SUBJECT LAND: 4-6 Adolph Street & 3-5 Pearson Street, Cremorne

Attachment 2 - PLN19/0827 - 4-6 Adolph Street & 3-5 Pearson Street, Cremorne - Decision Plans (S57A Plans)

TO: Michelle King (Statutory Planning)
FROM: Hayley McNicol (Urban Design)
DATE: 27 March 2020
SUBJECT: 4-6 Adolph Street and 3-5 Pearson Street, Cremorne
APPLICATION NO: PLN19/0827
DESCRIPTION: Development of the land for the construction of a seven storey building (plus basement and rooftop plant), a reduction in the car parking requirements associated with office and a food and drinks premises (no permit required for uses) and display of internally illuminated signage

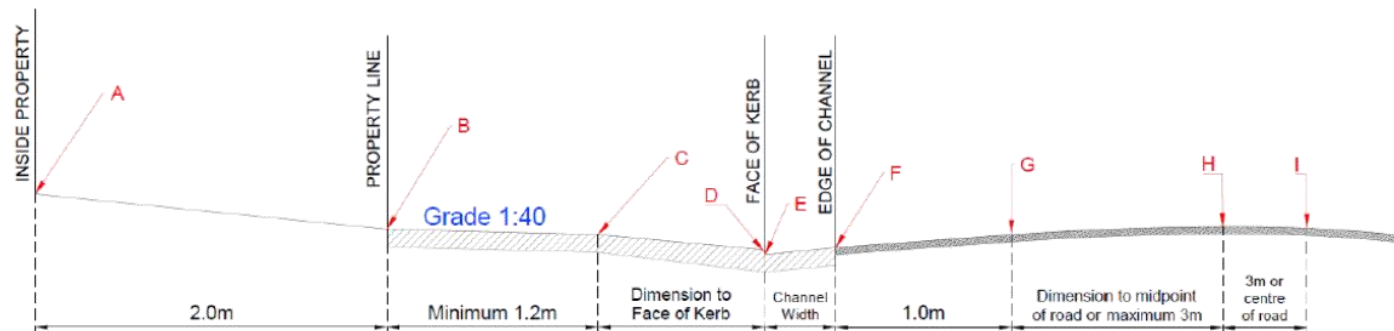
- o Please note the cross section must be fully dimensioned. As shown in the sketch below.
- o Please show both the existing and proposed surface.
- o The maximum allowable cross-fall between points B and C is 1:40 (2.5%).
- o A bullnose (max 60mm) is permitted at point D, however not compulsory.
- o The levels shown must be exact reduced levels, to three decimal points. Interpolation of levels is not acceptable.
- o The designer must demonstrate that an 85th or 99th percentile vehicle profile can traverse the design cross section as per the Australian/New Zealand Standard ground clearance template (AS/NZS 2890.1:2004).
- o Significant level changes to the existing footpath level B to C will require additional level design either side of the proposed crossing.
- o Please include any additional levels or changes in grade that are not shown in the diagram.

Vehicle Crossing – Cross Section

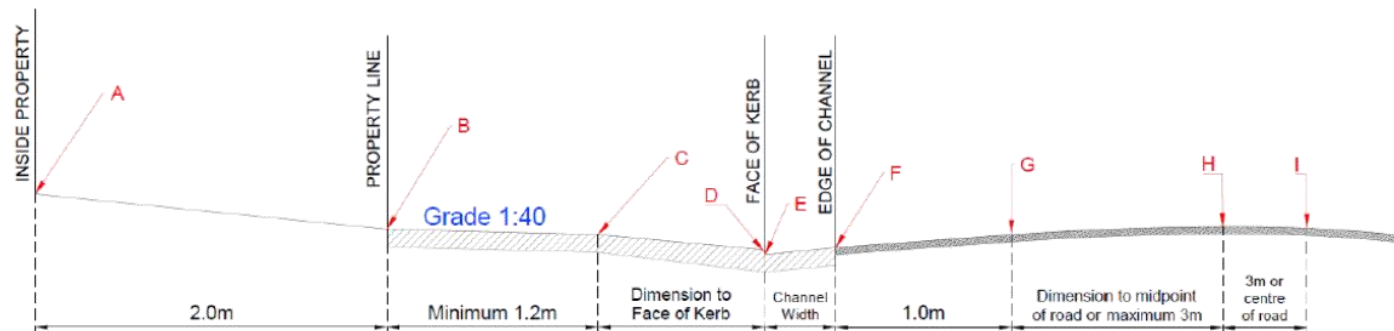
The designer is to submit a 1:20 scale cross section for each proposed vehicle crossing showing the following items:

- A. Finished floor level 2.0 metres inside property
- B. Property line surface level
- C. Surface level at change in grade (if applicable)
- D. Bullnose (max height 60mm) – must be clearly labelled
- E. Surface level at the bottom of the kerb
- F. Surface level at the edge of channel
- G. Road level 1.0 meter from the edge of channel
- H., I. Road levels

- o Please note the cross section must be fully dimensioned. As shown in the sketch below.
- o Please show both the existing and proposed surface.
- o The maximum allowable cross-fall between points B and C is 1:40 (2.5%).
- o A bullnose (max 60mm) is permitted at point D, however not compulsory.
- o The levels shown must be exact reduced levels, to three decimal points. Interpolation of levels is not acceptable.
- o The designer must demonstrate that an 85th or 99th percentile vehicle profile can traverse the design cross section as per the Australian/New Zealand Standard ground clearance template (AS/NZS 2890.1:2004).
- o Significant level changes to the existing footpath level B to C will require additional level design either side of the proposed crossing.
- o Please include any additional levels or changes in grade that are not shown in the diagram.

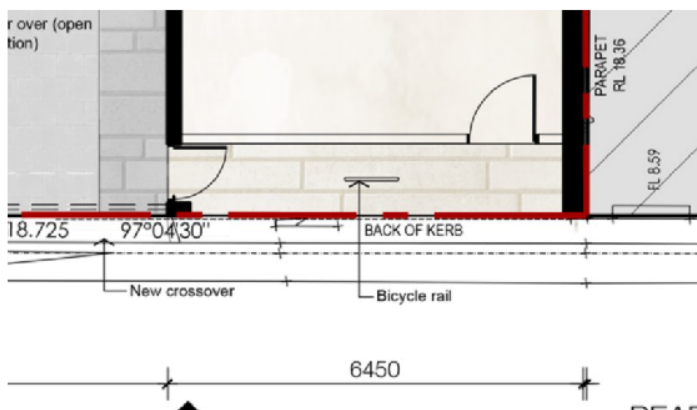
Visitor spaces - 1 visitor hoop has been relocated to Pearson St. Clarification is required to confirm if the bike hoop is within an enclosed space or directly accessible from the footpath (shown below). The south elevation does not show the visitor space. If the visitor space is within an enclosed area, this is not considered an acceptable outcome as the space would not be visible and easily accessible to visitors and two bicycles parked at the hoop would obstruct access through this space. Original comments recommended 4 visitor spaces to meet the best practice recommendation. Given the narrow footpaths surrounding the site, if only 2 visitor spaces can be provided at the ground floor, provision of an additional 2 spaces within the employee bicycle parking area would be considered acceptable alternative.
